Access Compliance Report Public Rights-of-Way (Curb Ramps)

Intersection ID: 3718 Main Street: CROFTON_SPRINGS_DR Cross Street: DAVIS_LAKE_PY Location: W

ADA ID: 7BD1DC2FF65D Ramp Type: Perp Initial Pass/Fail: Fail Overall Compliance: No Severity Score: 47.5

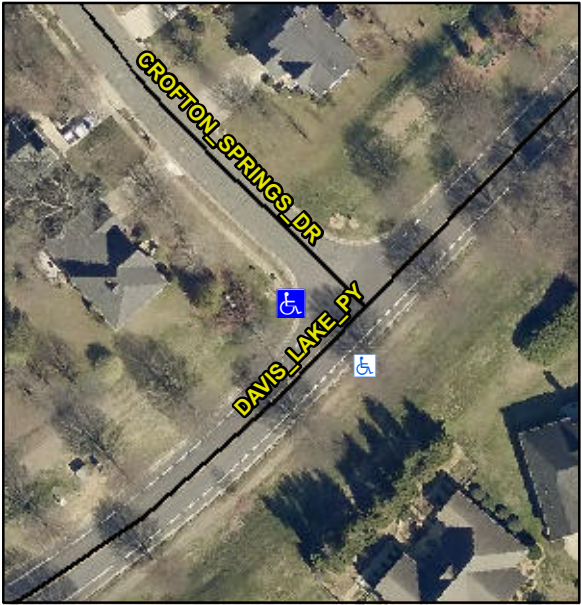
PROW/ADA:
Not Found, R304.5.1, R304.2.2

Compliance	Description	Data	Compliance	Description	Data
N/A	Ramp Length (in)	49.0	No	Ramp Slope (%)	9.9
No	Ramp Width (in)	28.0	Yes	Ramp XSlope (%)	1.4
N/A	Flare Type LT	N/A	N/A	Flare Type RT	N/A
N/A	Flare Slope LT (%)	N/A	N/A	Flare Slope RT (%)	N/A
N/A	Flare Traversable LT?	N/A	N/A	Flare Traversable RT?	N/A
N/A	Landing Length (in)	N/A	N/A	DWS Provided?	N/A
N/A	Landing Width (in)	N/A	N/A	DWS Contrast?	N/A
N/A	Landing Slope (%)	N/A	N/A	DWS Length (in)	N/A
N/A	Landing X Slope (%)	N/A	N/A	DWS Full Width?	N/A
N/A	Landing Curb? (Y/N)	N/A	N/A	DWS Offset (in)	N/A
N/A	Shared Landing?	N/A			
N/A	Gutter Ponding?	N/A	N/A	Gutter Slope (%)	N/A
N/A	Gutter Lip Ht (in)	N/A	N/A	Gutter X Slope (%)	N/A
N/A	Painted X Walk1?	No	N/A	Painted X Walk2?	N/A
	X Walk 1 Direction	To SE		X Walk 2 Direction	N/A
N/A	X Walk 1 Width (in)	N/A	N/A	X Walk 2 Width (in)	N/A
	X Walk 1 Slope (%)	0.3		X Walk 2 Slope (%)	N/A
	X Walk 1 X Slope (%)	0.2		X Walk 2 X Slope (%)	N/A

Possible Solutions:
Remove & Replace Entire Ramp.
